TK Elevator EOX

The following shows some examples of what should be done & how to prove that the work was performed.

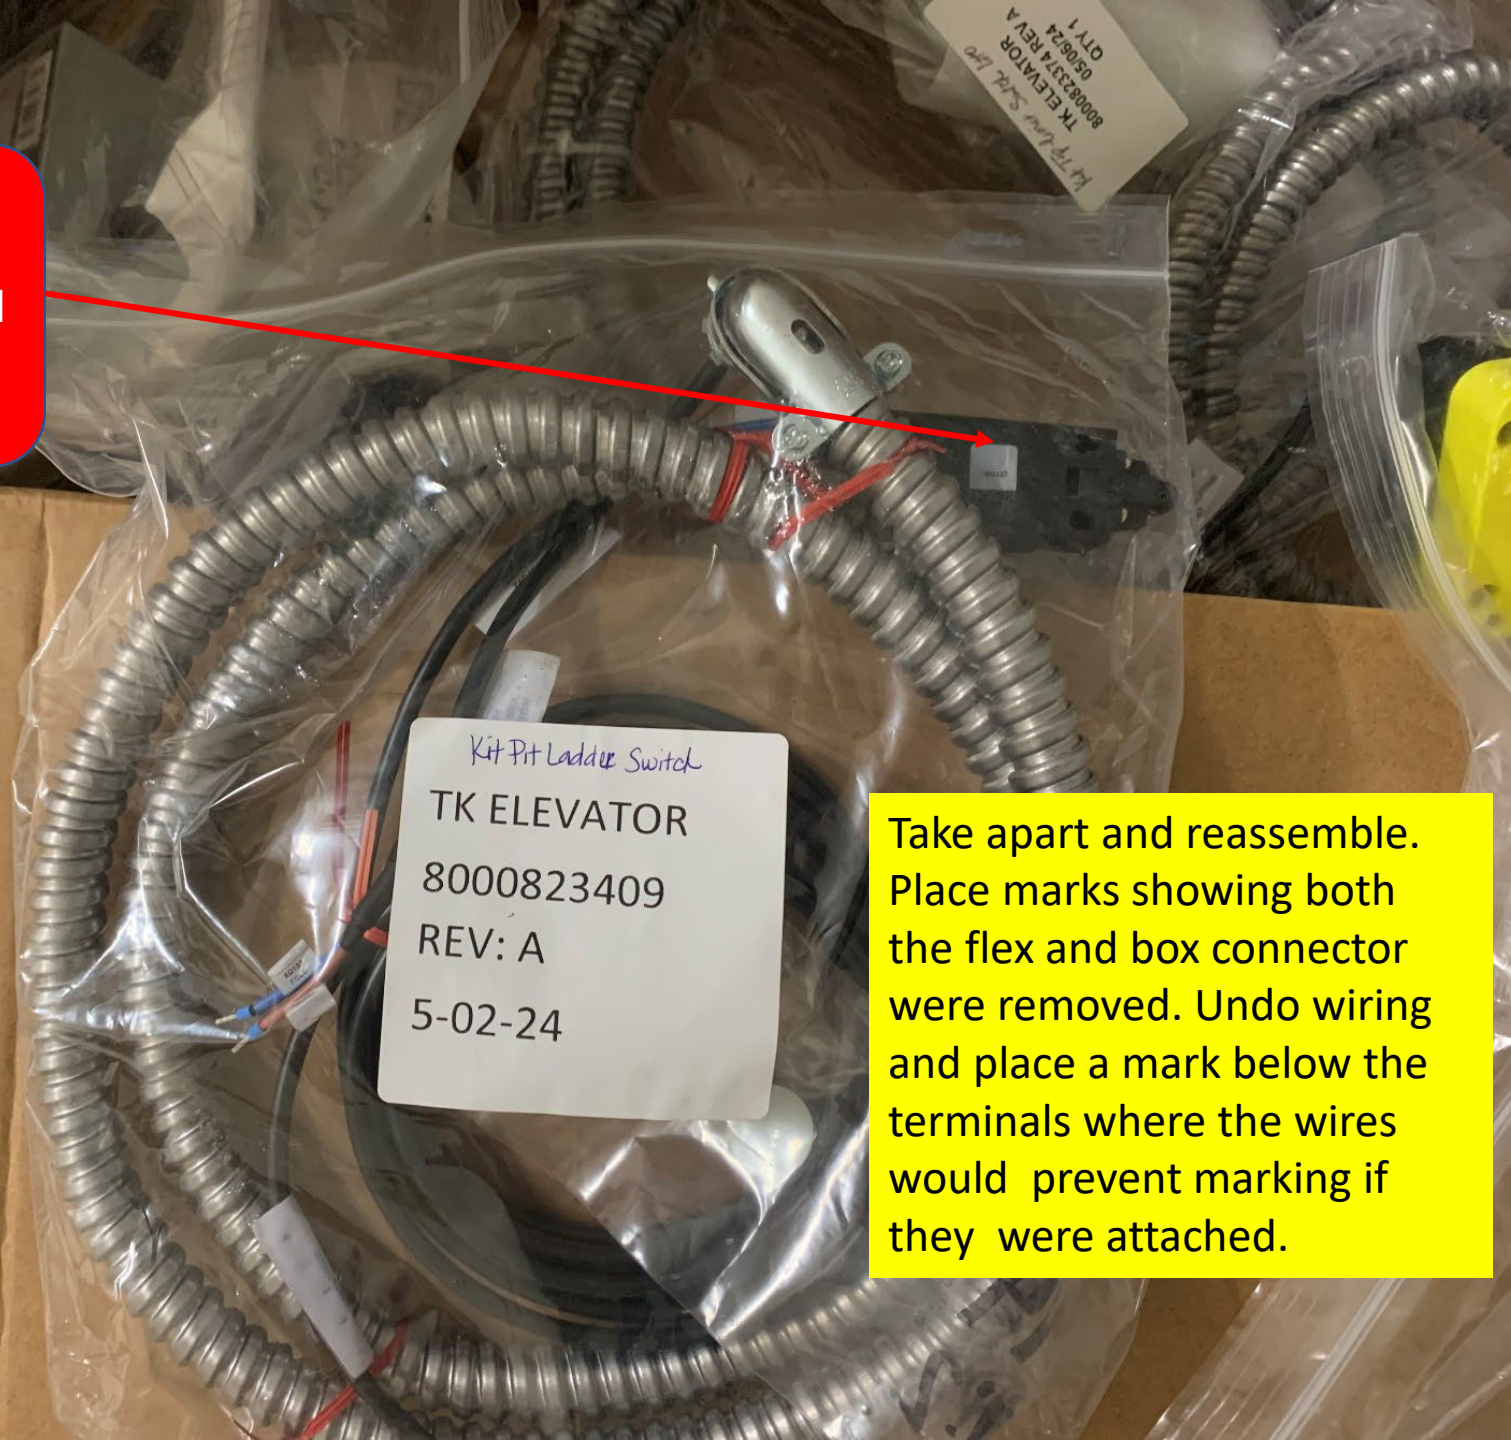
Pit stop switch factory piped and wired with plug connector. Violation of Article IV, Par. 2 (d) and Par. 3 (7) of the collective bargaining agreement.

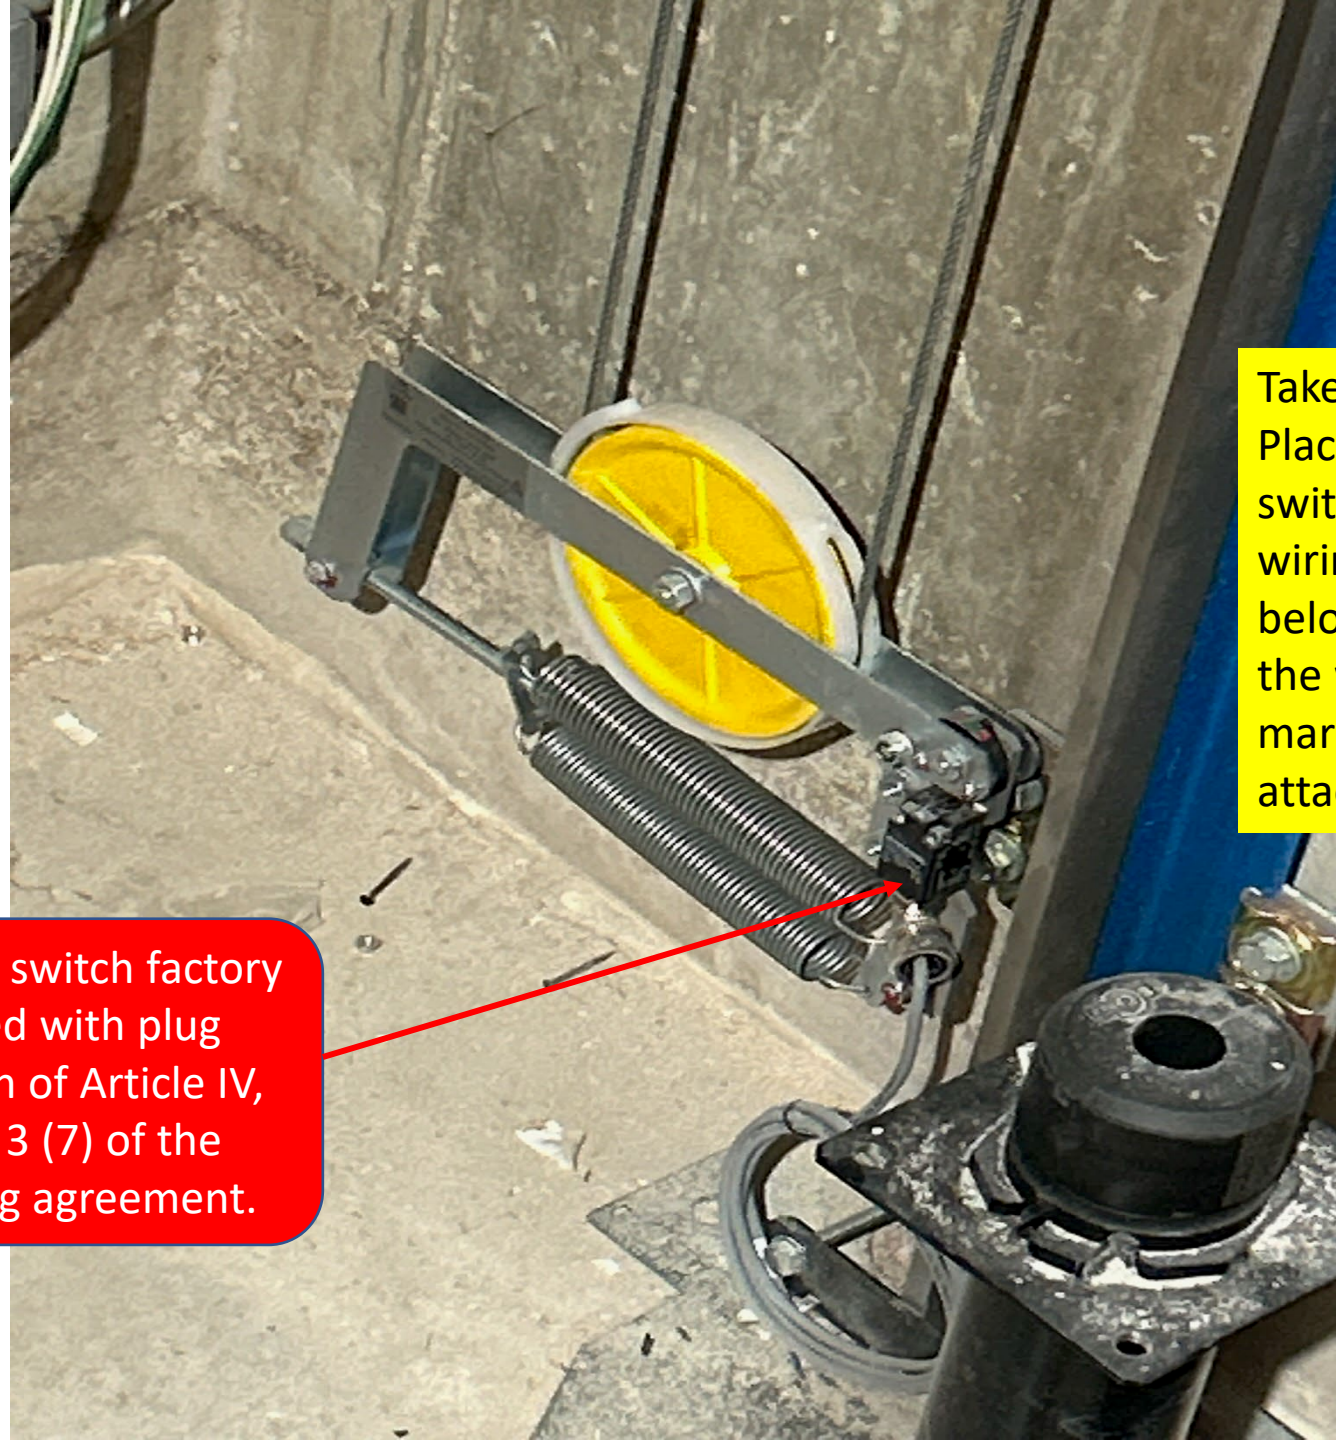
Governor switch factory wired.
Violation of Article IV, Par. 2 (d) of
the collective bargaining
agreement.

(d) All wiring, conduit, and raceways from main line feeder terminals on the controller to other elevator apparatus and operating circuits. Controllers are not to be shipped from the factory with extended wiring attached thereto.

Take apart and reassemble. Place marks showing the switch was removed. Undo wiring and place a mark below the terminals where the wires would prevent marking if they were attached.

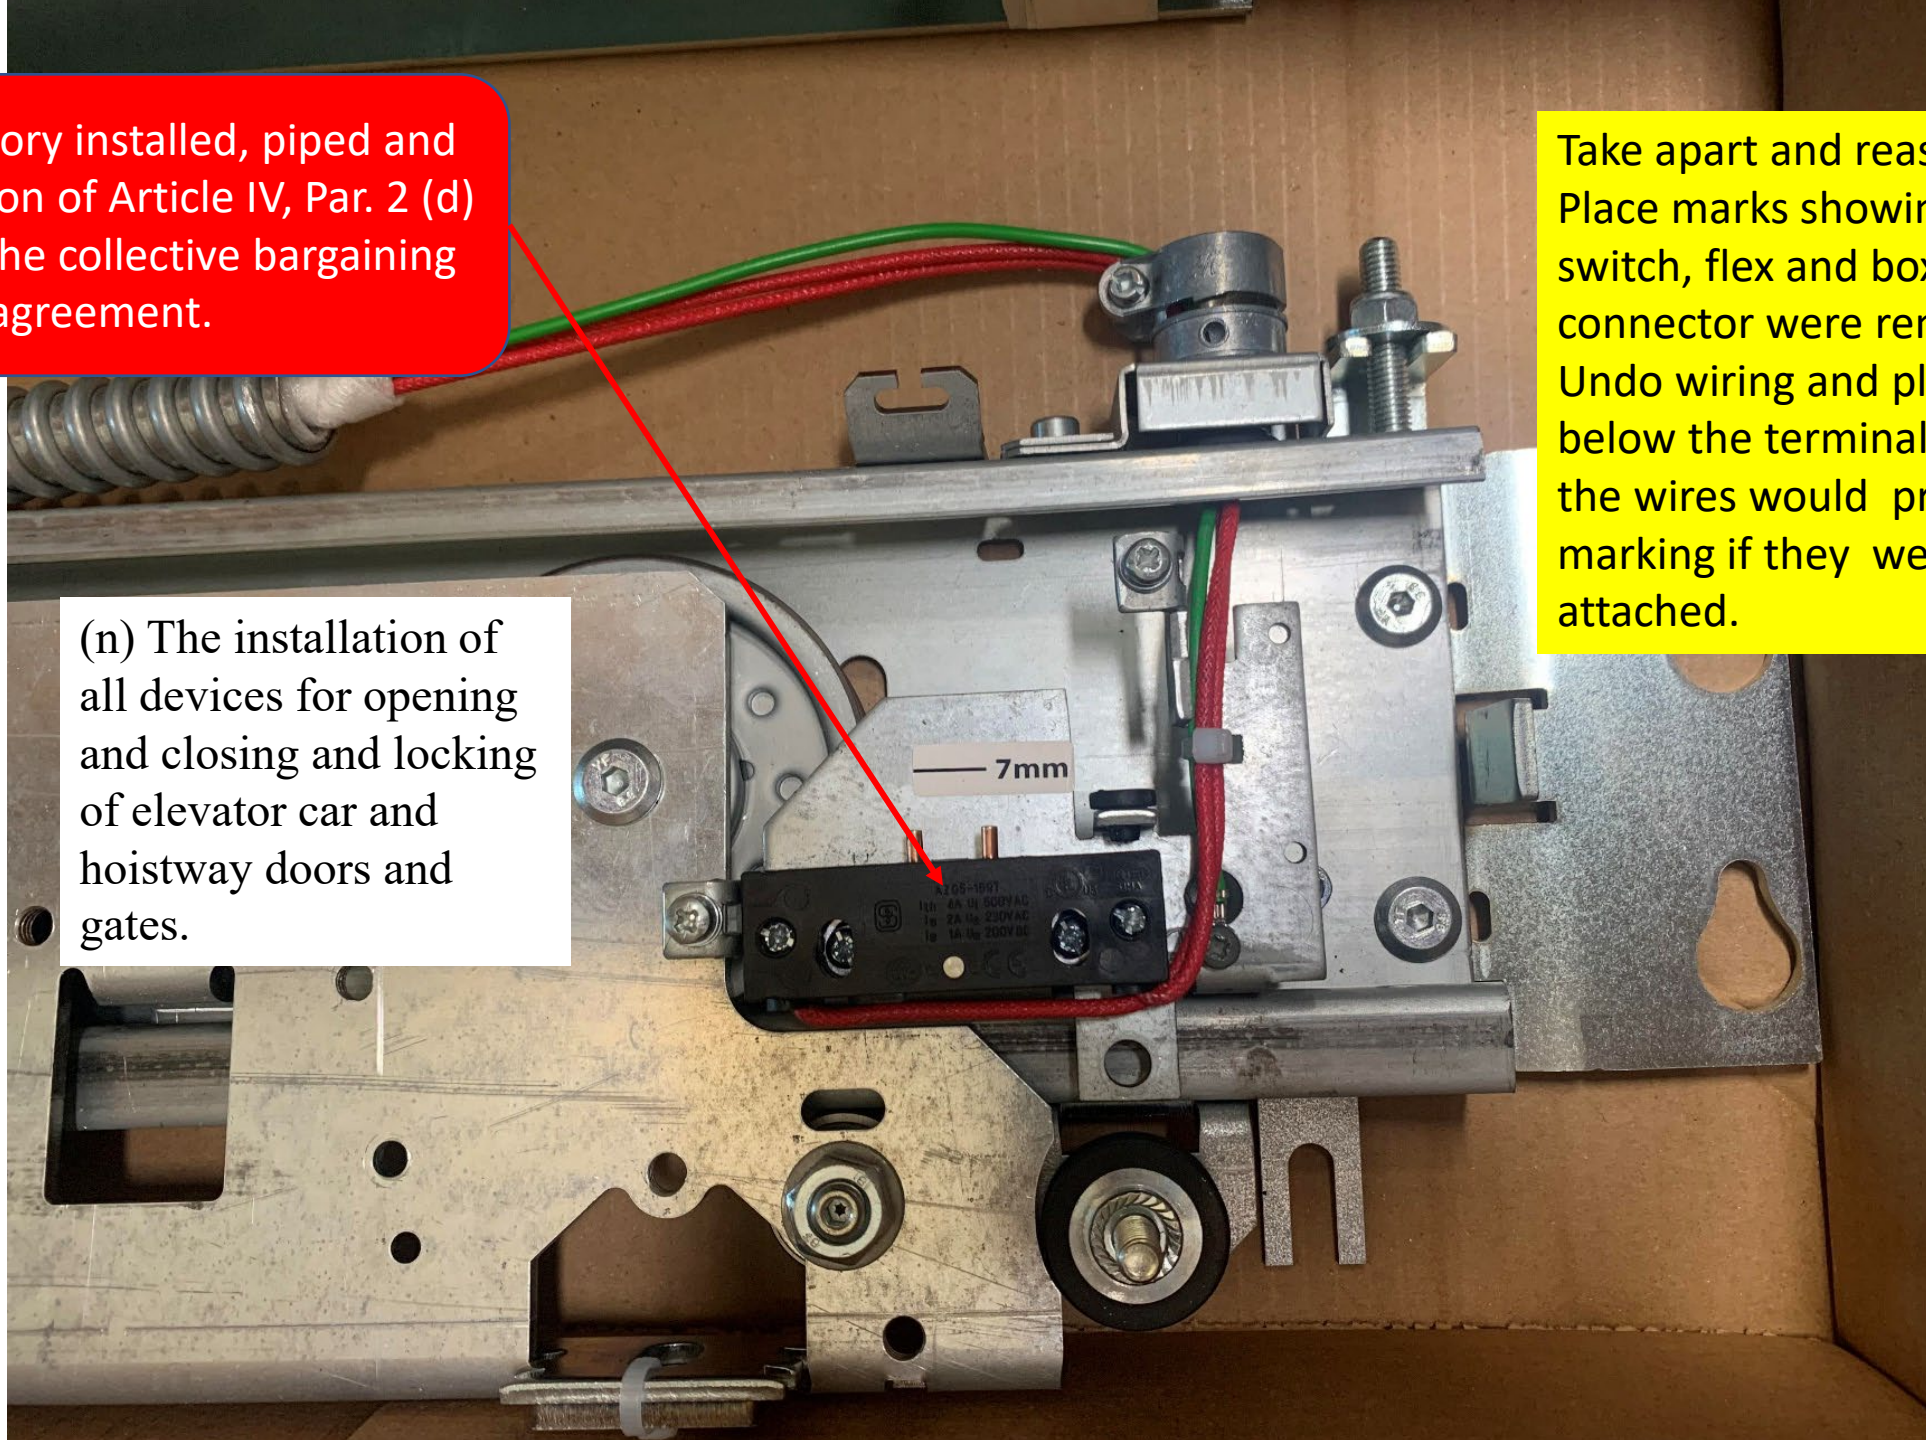
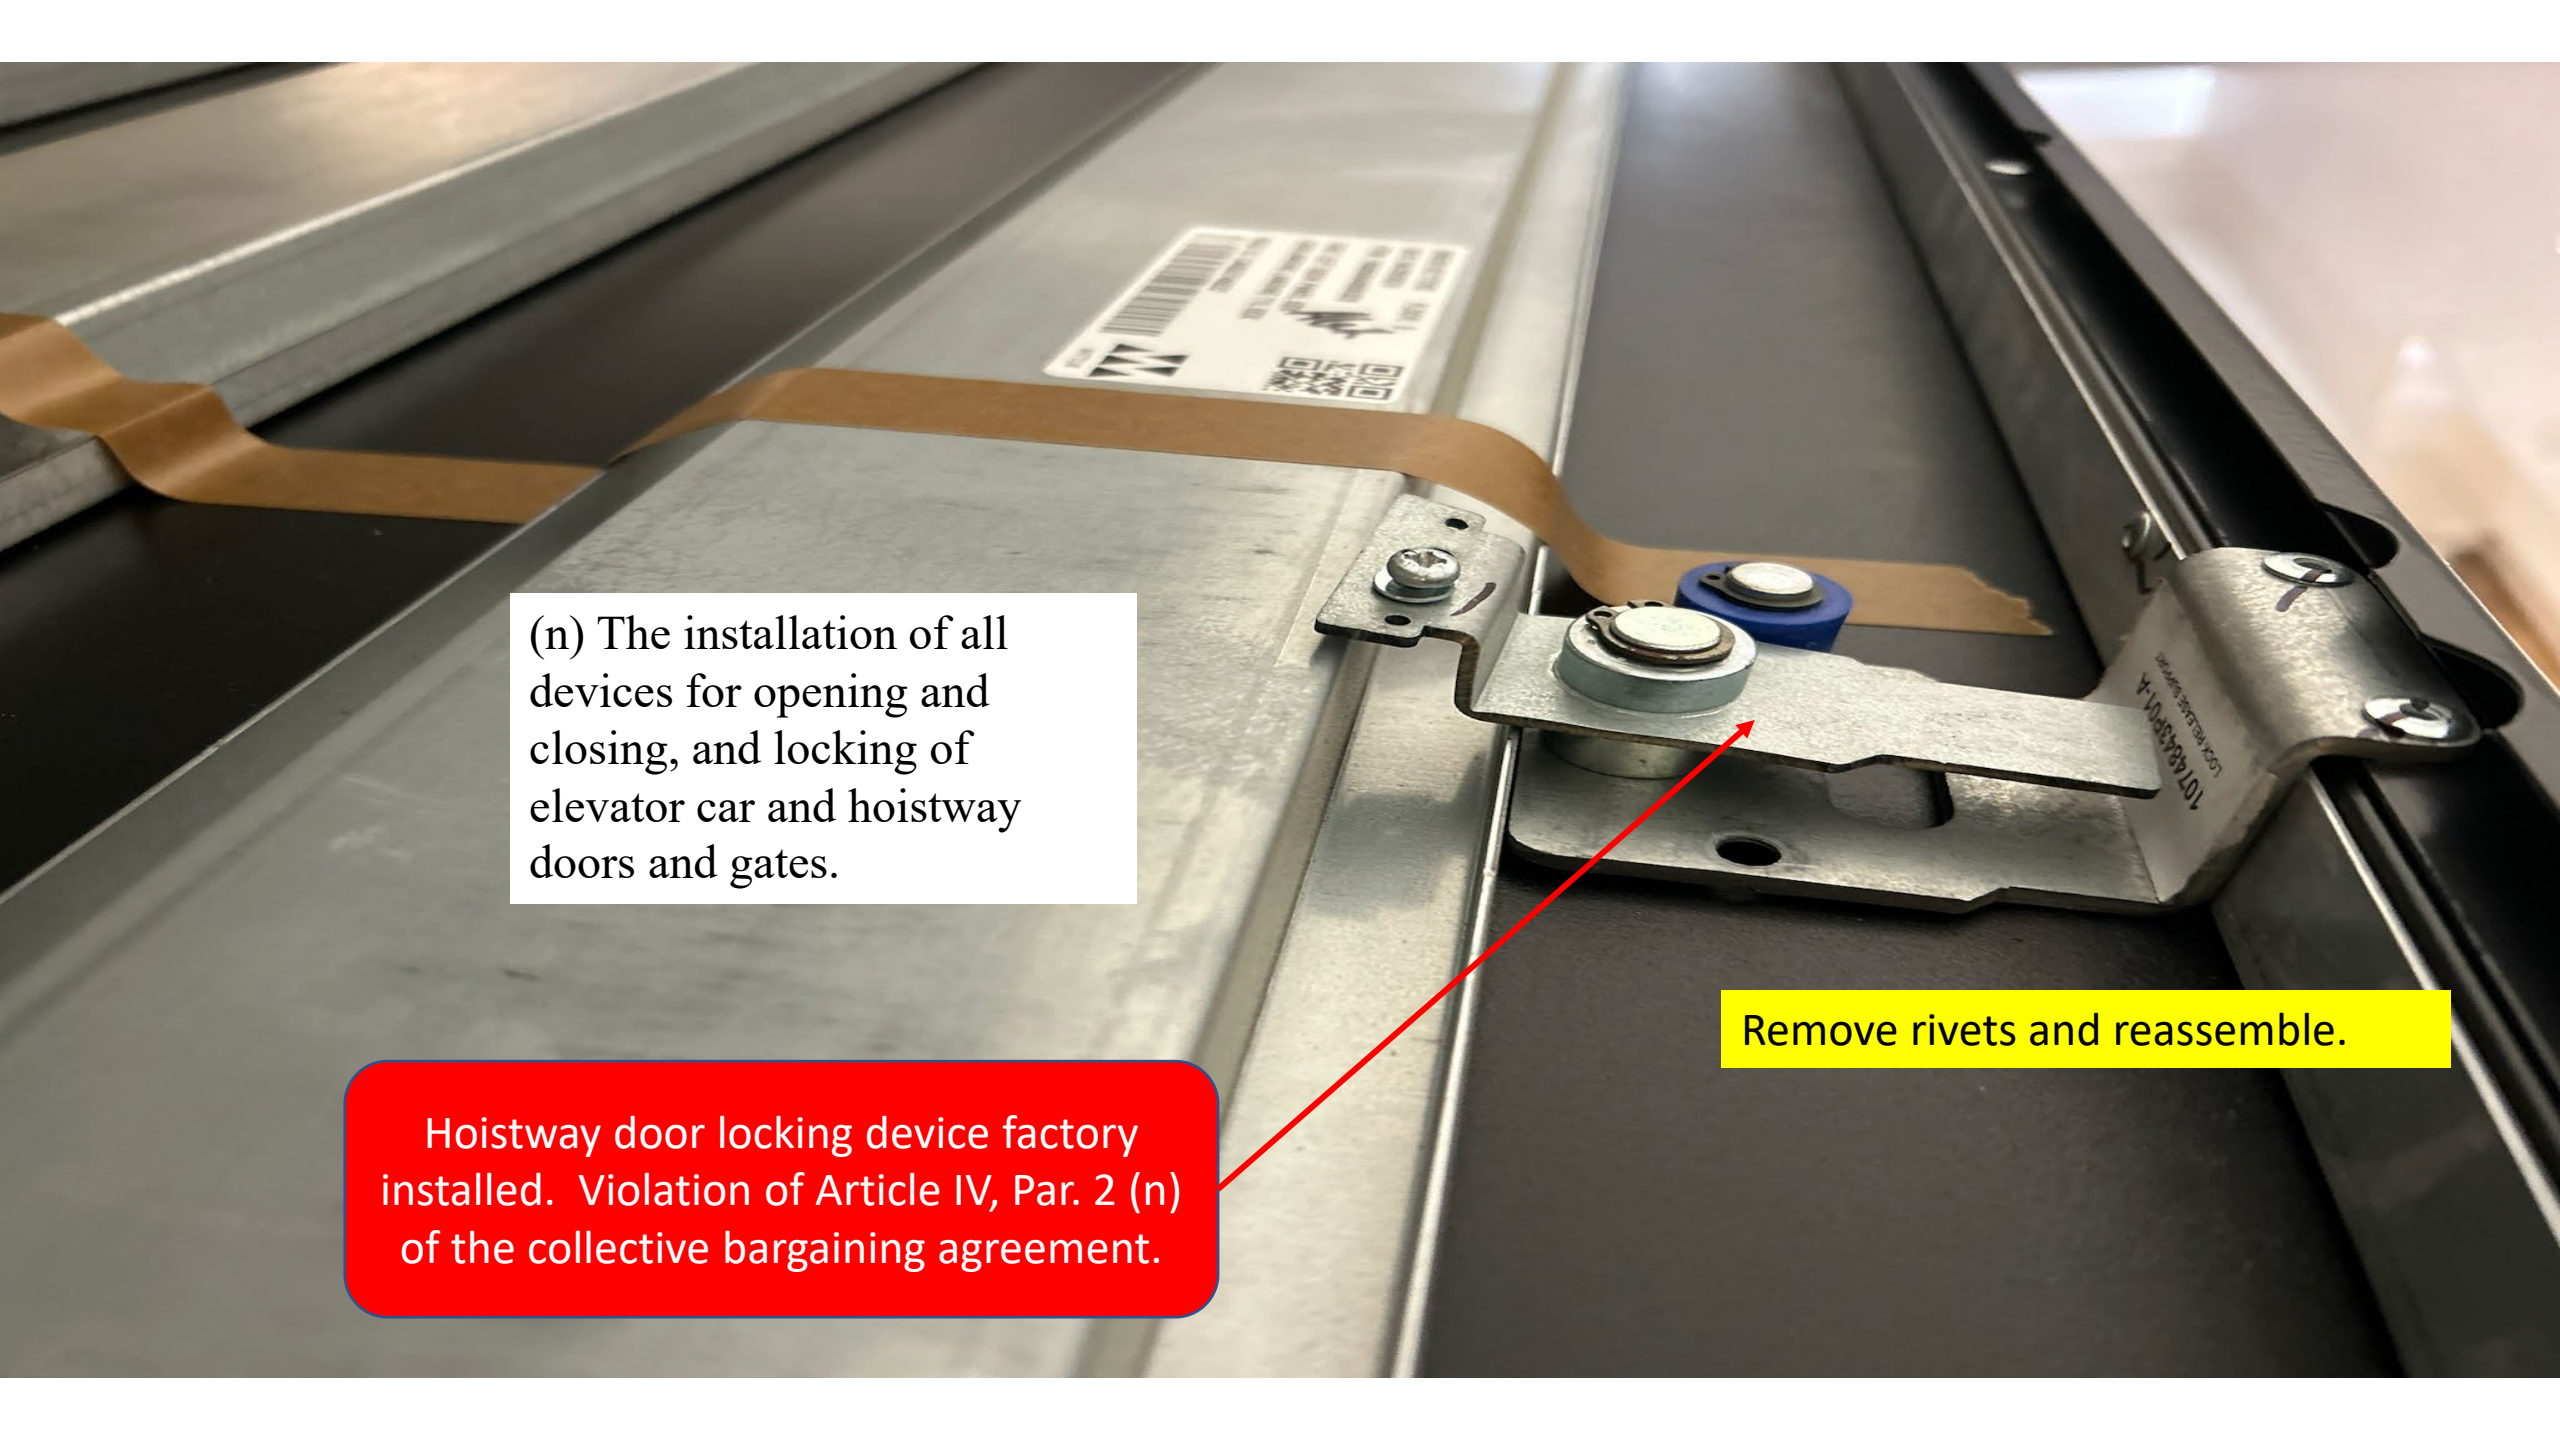
Hoistway fixture boxes factory installed. Violation of Article IV, Par. 2 (d) of the collective bargaining agreement.

(d) All wiring, conduit, and raceways from main line feeder terminals on the controller to other elevator apparatus and operating circuits.

Take apart and reassemble. Place marks showing both the flex and box connector were removed.
